# **Supporting presentation for comments #337 & #338**

P802.3dj Interim Meeting, Minneapolis, Sep 2025

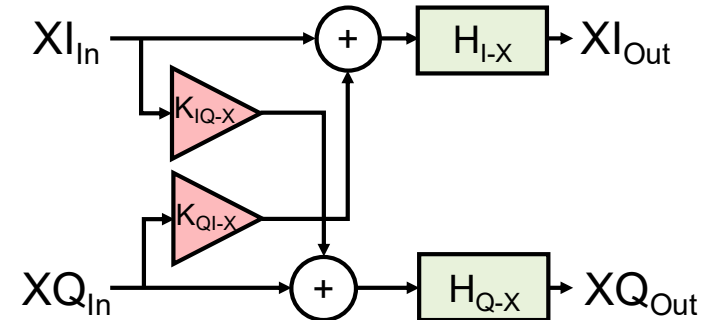
- A Reference Post Equalizer was proposed to compensate transmit I-Q skew and quadrature phase error
- The recommended 2x2 real MIMO with four T-spaced FIR filters per polarization may mask other transmitter impairments (crosstalk, frequency-dependent mismatch, etc.)
- Comment #338 proposes a simpler equalizer that achieves the same goal without any possible unwanted impairment masking

# Comment 337. Reference Equalizer Taps

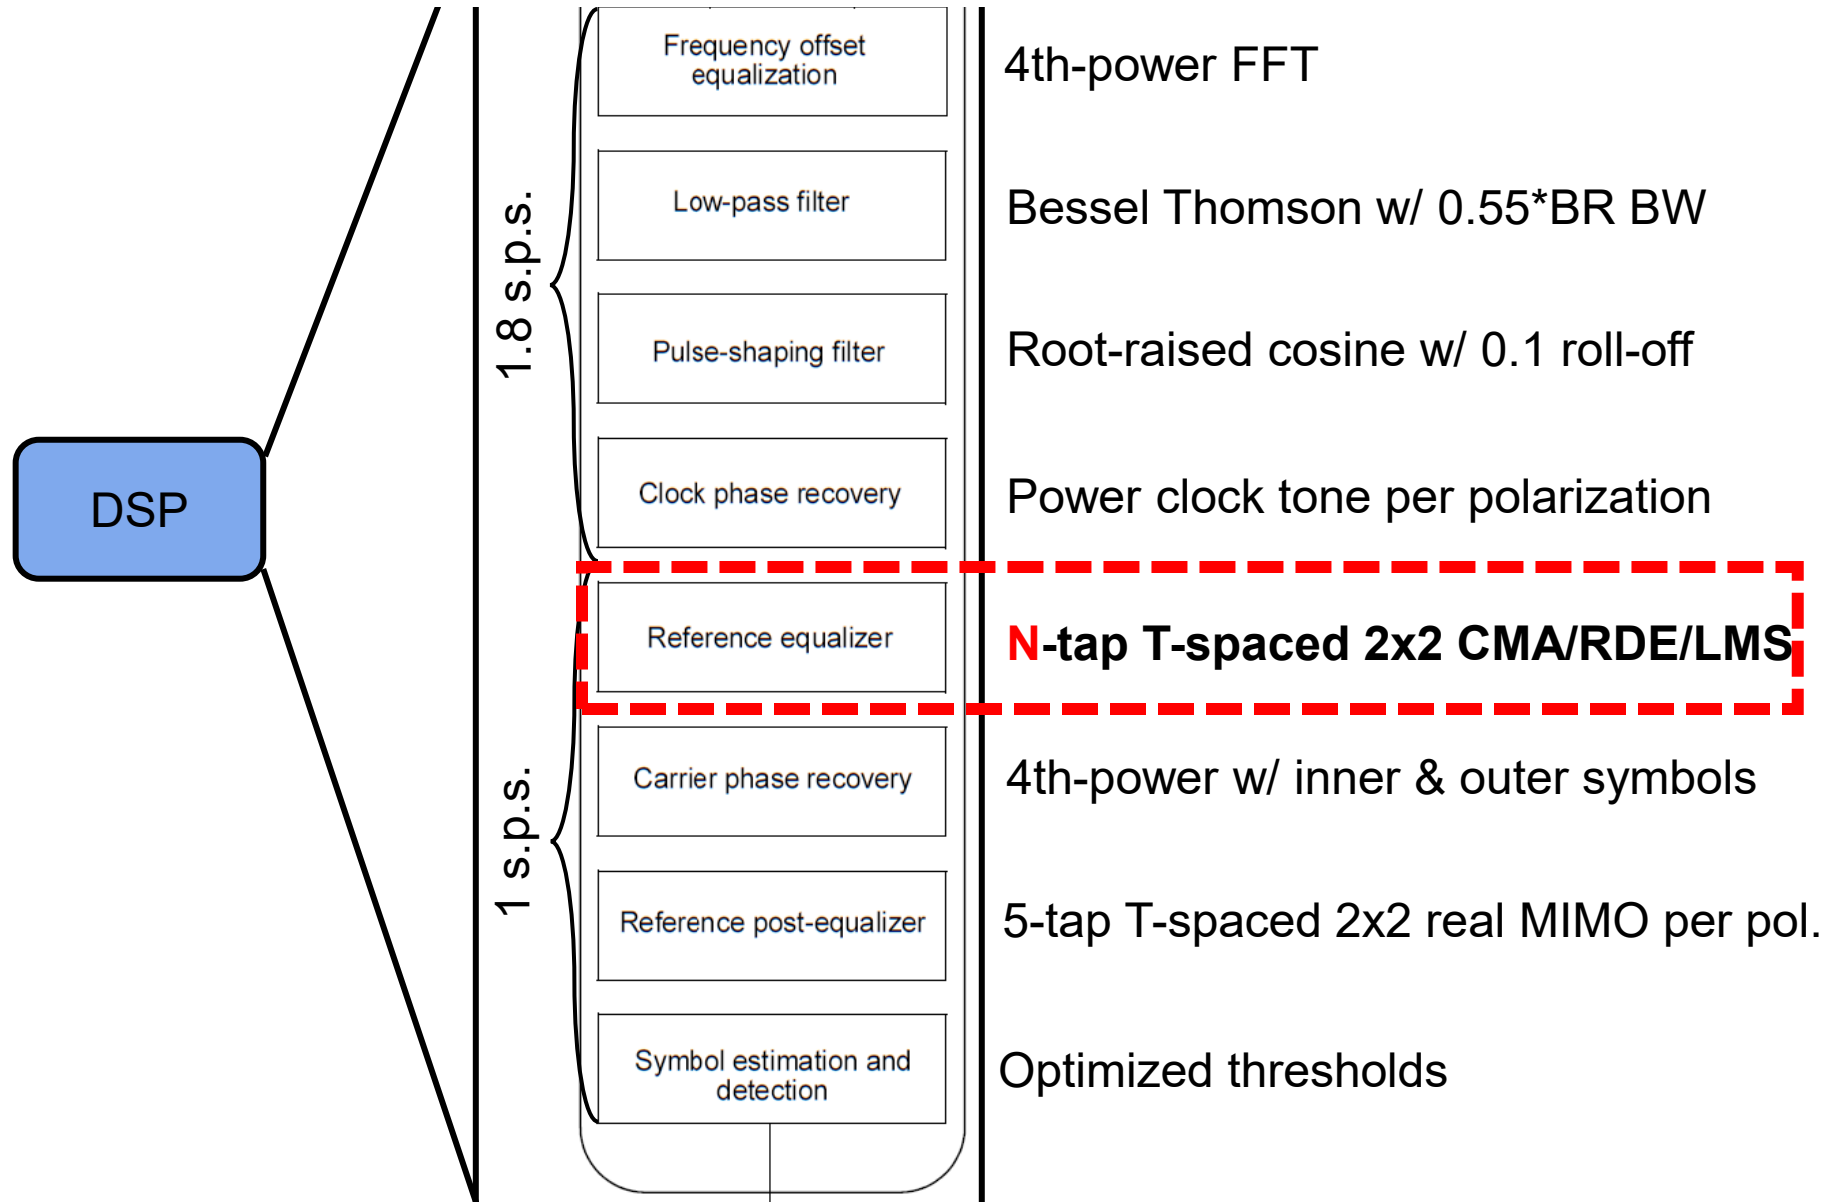
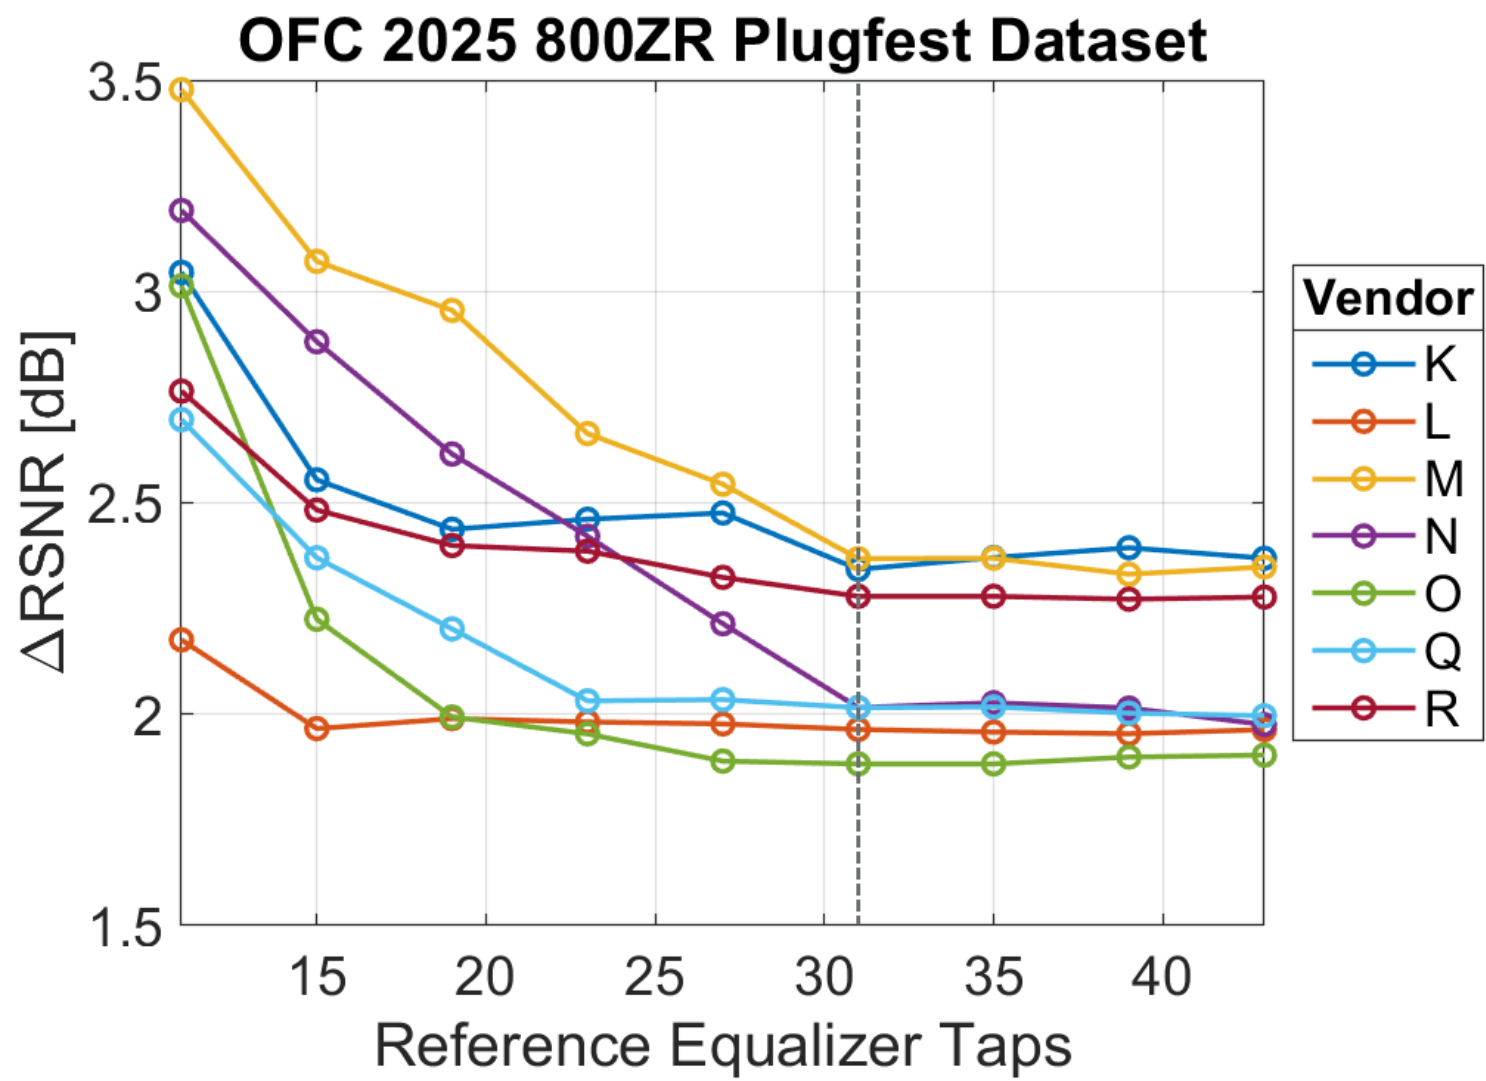
CI 185A	SC 185A.2.3.5	P914	L 19	# 337
Williams, Tom		Cisco		
Comment Type	TR	Comment Status X		
Reference equalizer misses to specify the number of taps.				
A supporting presentation will be provided				
SuggestedRemedy				
Add a specified number of taps to the description.				
Propose a 31 tap equalizer.				
"... with an adaptive 31 tap T-spaced feed-forward equalizer ..."				
Proposed Response		Response Status O

# Comment 338. Post Reference Equalizer Implementation

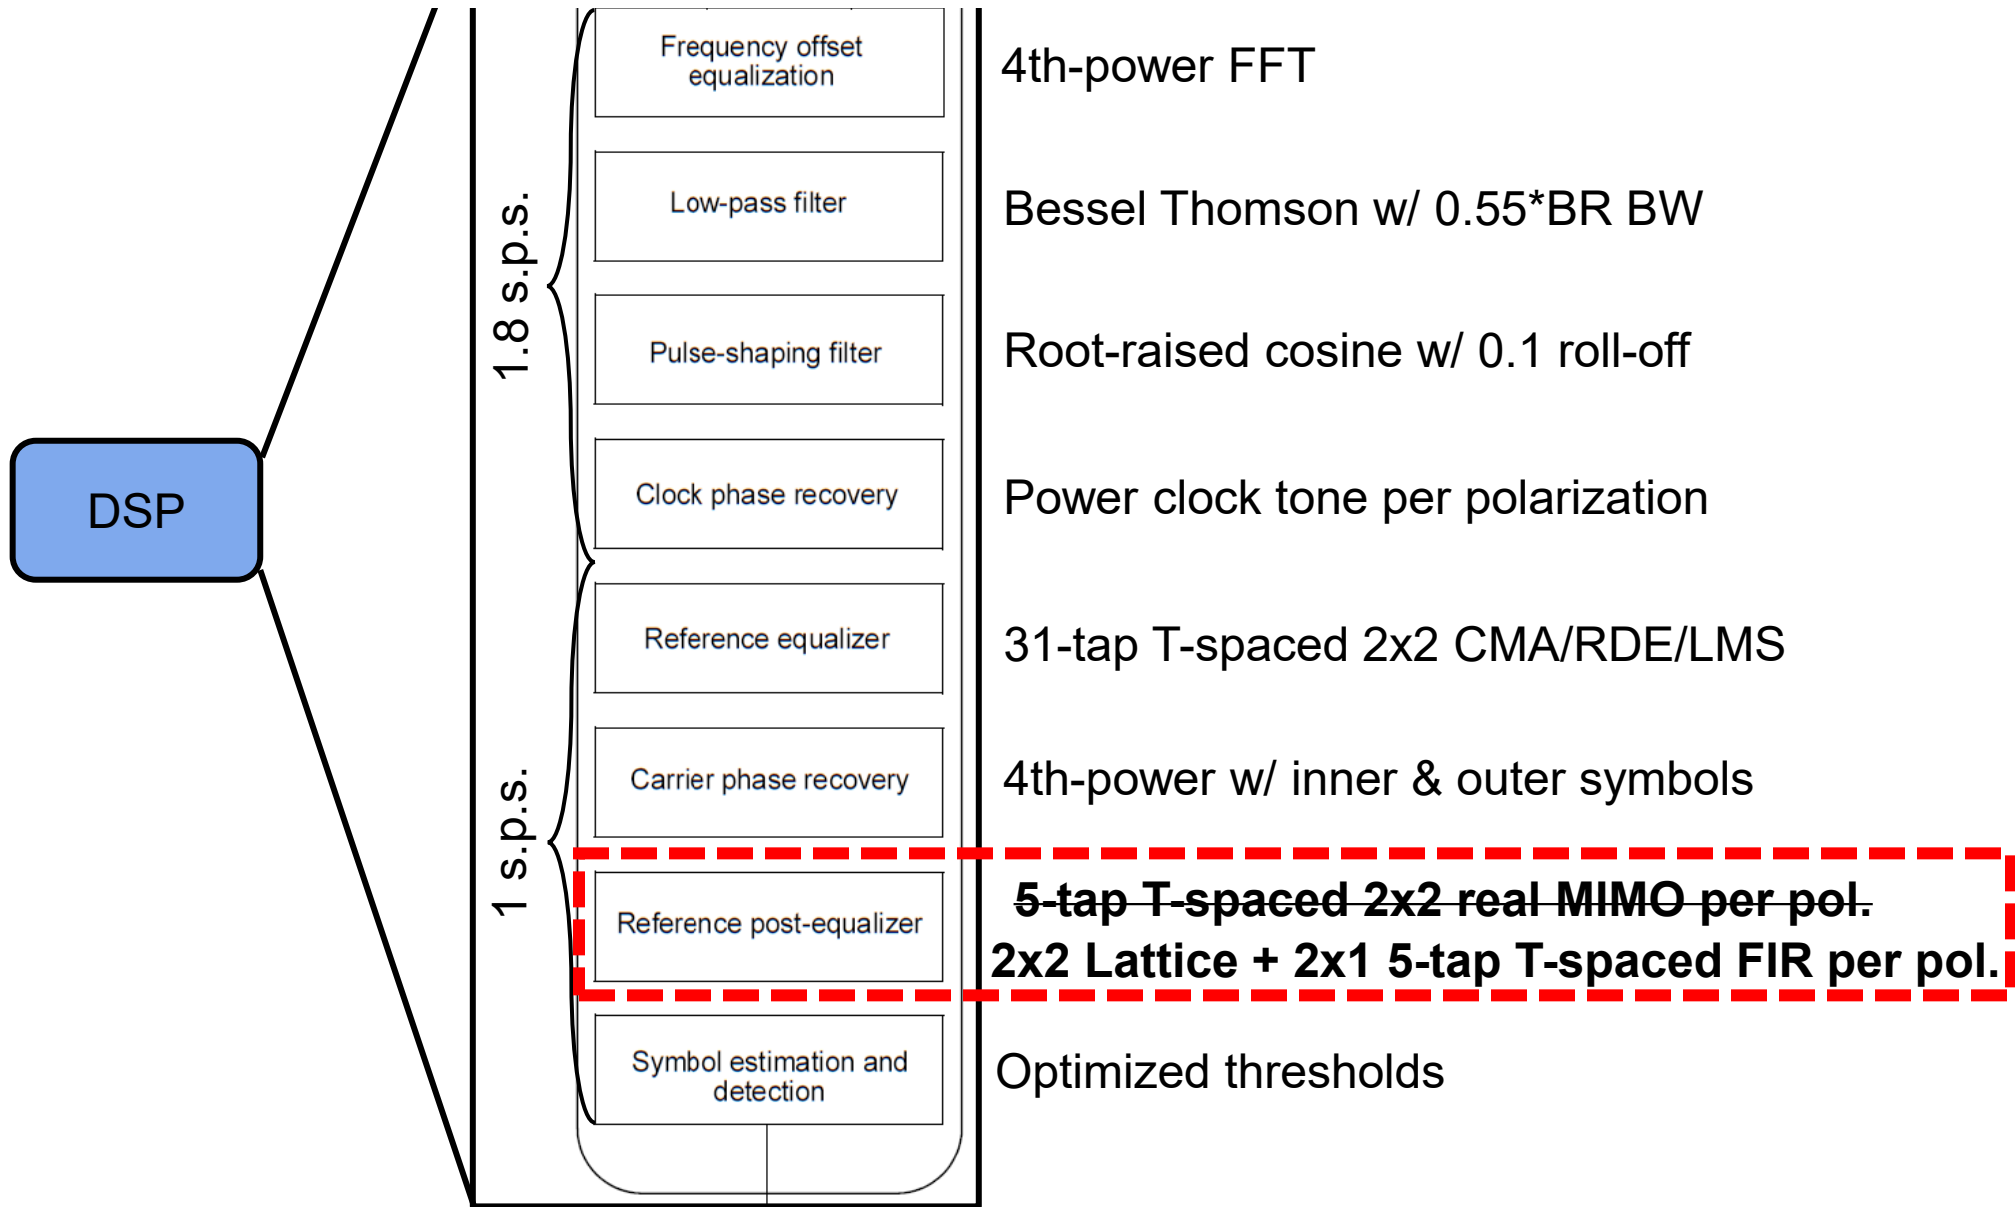
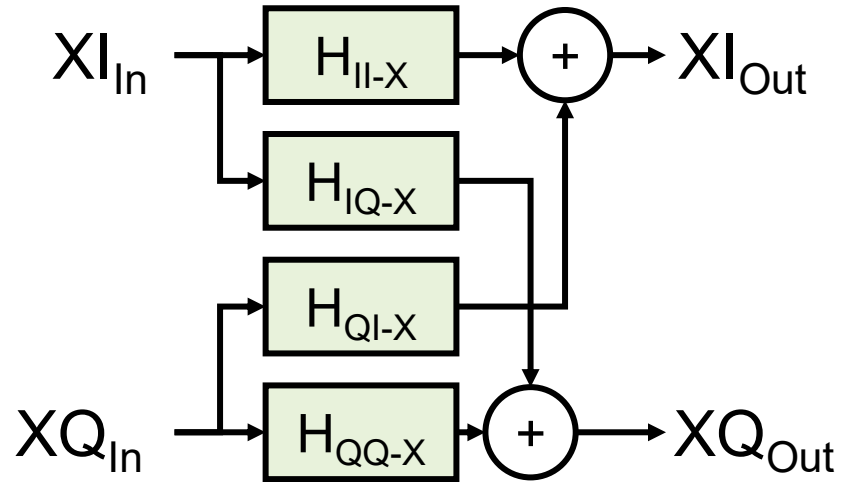
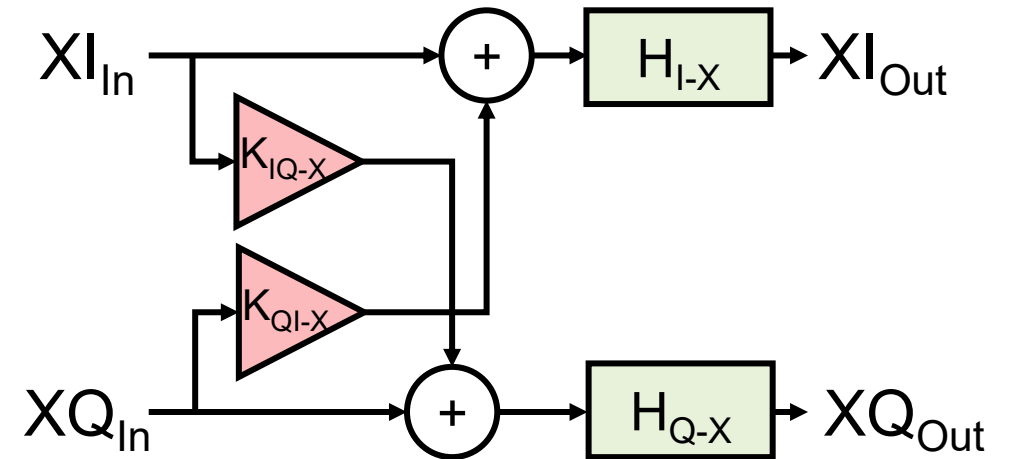
CI 185A	SC 185A.2.3.7	P 914	L 29	# 338
Williams, Tom		Cisco		
Comment Type	TR	Comment Status X		
The purpose of ETCC is to quantify the penalty due to transmitter-only impairments. The addition of the reference post equalizer in D2.1 is proposed to compensate for a transmitter-caused penalty (IQ skew) which allows poorer transmitters to pass the test and pushing the burden to the link receiver to compensate.				
It is unclear if this reference post equalizer should remain in the specification.				
However, to limit the burden to the link receiver, propose to limit the Reference Post equalizer to 5 taps and only in the through paths which is sufficient to address the skew. And a seperate 1-tap phase error correction.				
A supporting presentation will be provided				
SuggestedRemedy				
Rewrite 185A.2.3.7 to:				
A reference post-equalizer for each polarization is placed after the carrier phase recovery, and used to compensate for transmit I-Q skew and transmit I-Q phase error impairments.

The I-Q phase error is corrected via a 1-tap adaptive feed forward crosstalk cancellation between I-Q pairs.				
The I-Q skew is corrected via four independent 5-tap adaptive T-spaced feed forward filters for each of the XI, XQ, YI, YQ signals, where T is the symbol period.				
Proposed Response		Response Status O
